SERVICE BULLETIN

NUMBER: 03-70-12R
DATE: 12/13/12
REVISED: 05/22/13

SUBJECT: Repair Procedure for High-Pitched Sound from Extension Housing Area Using Latest Generation Production Parts

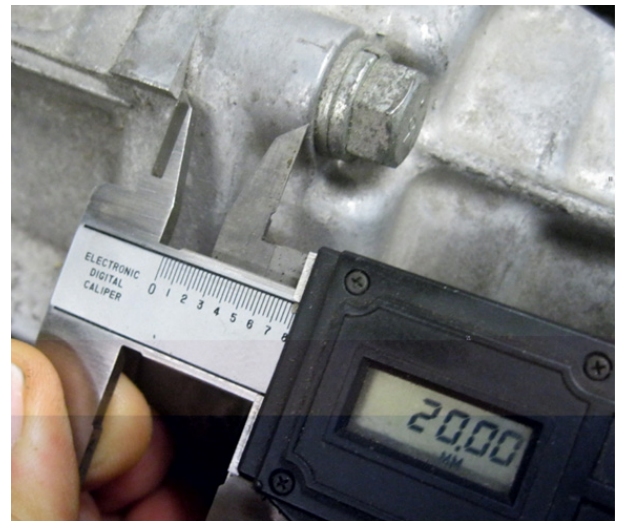
NOTE: When replacing the extension case, the output oil seal, p.n. 806735210 must be replaced. If the transmission number is prior to 5588478, and you are replacing the extension case, shorter case bolts, p.n. 800610940, (quantity 9) must also be installed due to the thinner retaining bolt boss areas of the replacement extension case (16mm vs. 20mm) as shown in the photos below.

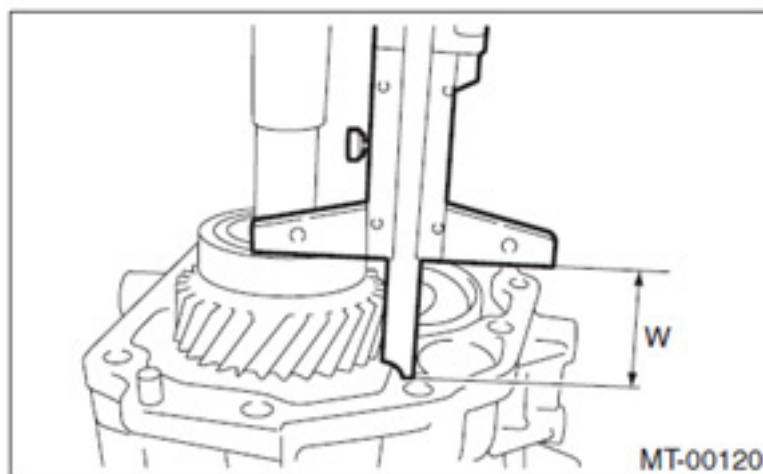
- Measure height “W” between transfer case sealing surface and taper roller bearing outer race on the transfer driven gear.

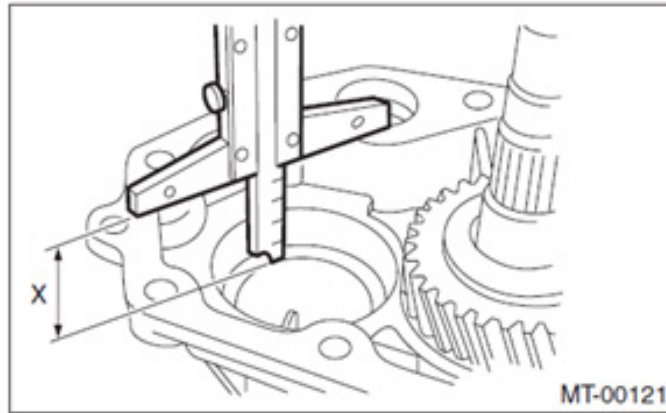
- With the bearing outer race, dish plate and thrust washer removed, measure depth “X” of the bearing bore of the extension case.

- Calculate the required thrust washer thickness “T” using the revised formula below:

$$T = X - W - (1.715 \text{ to } 1.765 \text{ mm (0.0686 to 0.0706)})$$

NOTE: This formula has been revised from the formula shown in the Service Manual to work with the new dish plate and extension case assembly.

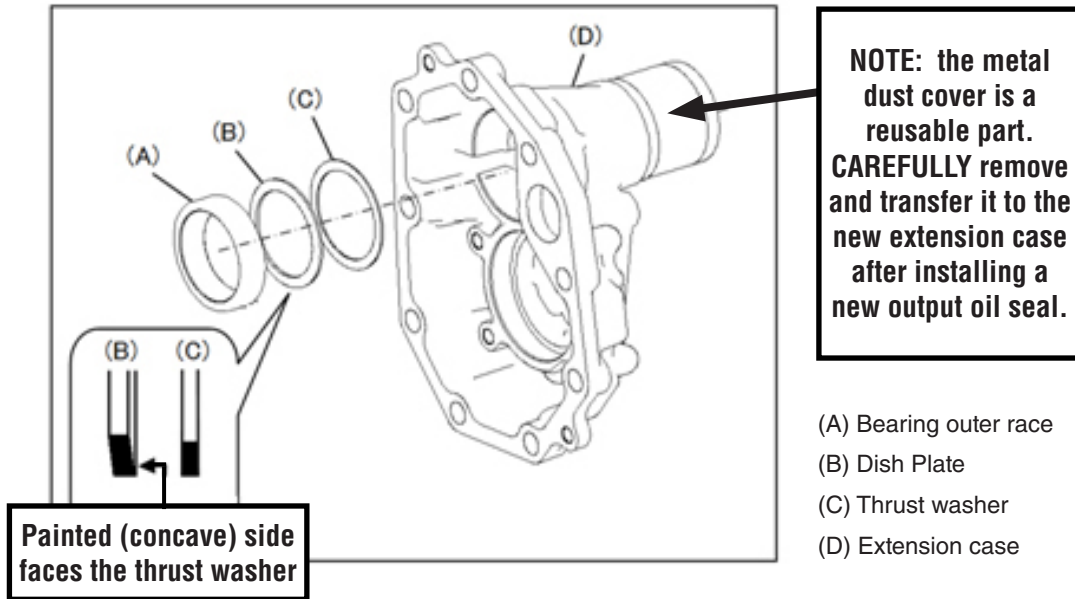
- Once the proper thrust washer has been selected, assemble the new extension case as shown in the illustration below.
